CITY of NOVI CITY COUNCIL

Agenda Item 6
June 27, 2016

SUBJECT: Approval of the request of Pulte Homes for Dixon Meadows, JSP 14-46, with Zoning Map Amendment 18.709, to rezone property in Section 10, located on the east side of Dixon Road, north of Twelve Mile Road from RA (Residential Acreage) to RT (Two-Family Residential) subject to the related Planned Rezoning Overlay (PRO) Agreement, and corresponding PRO Plan. The property totals 22.36 acres and the applicant is proposing to construct a 90-unit single family residential detached site condominium.

Figure 1. City of Novi Regulated Wetland & Woodland Map (approximate property boundary shown in red). Regulated Woodland areas are shown in green and regulated Wetland areas are shown in blue).

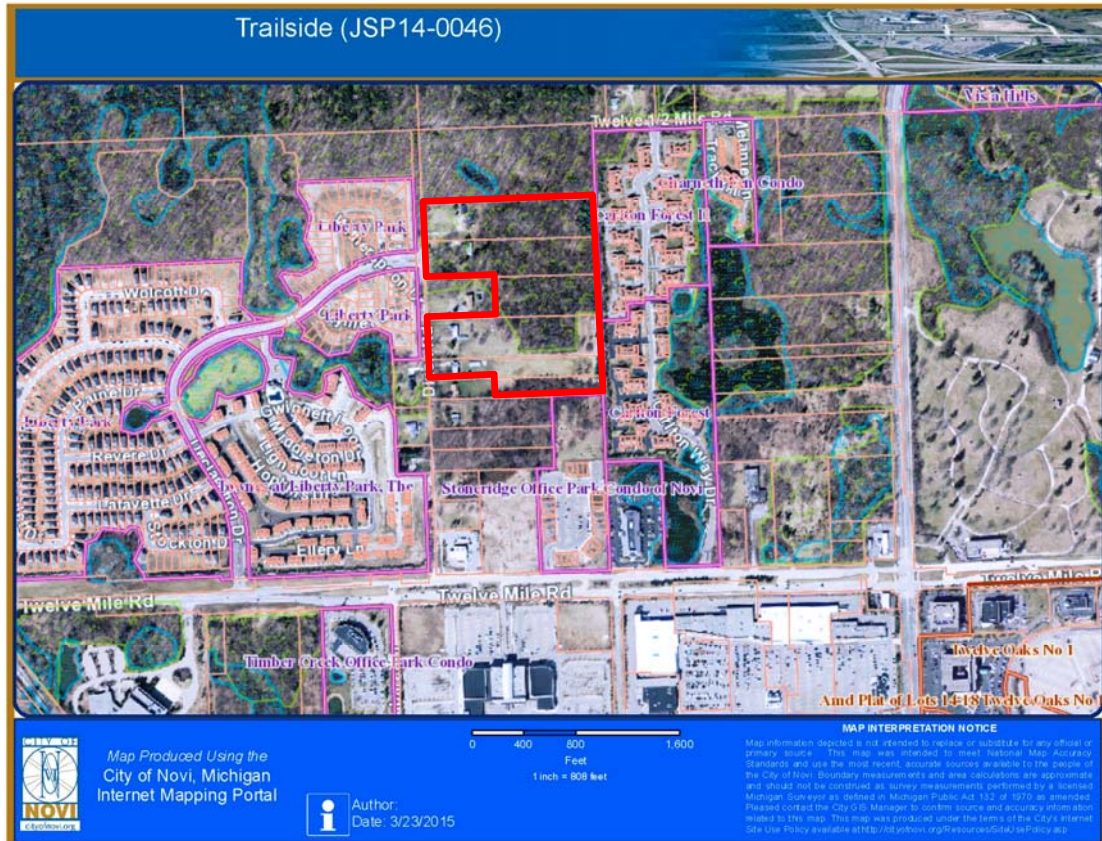
The entire site is approximately 22 acres with regulated woodland mapped across a significant portion of the property. The mapped City-regulated woodlands area is generally located within the northern and central sections of the site (see Figure 1). It appears as if the proposed site development will involve a significant amount of impact to regulated woodlands and will include a significant number of tree removals.
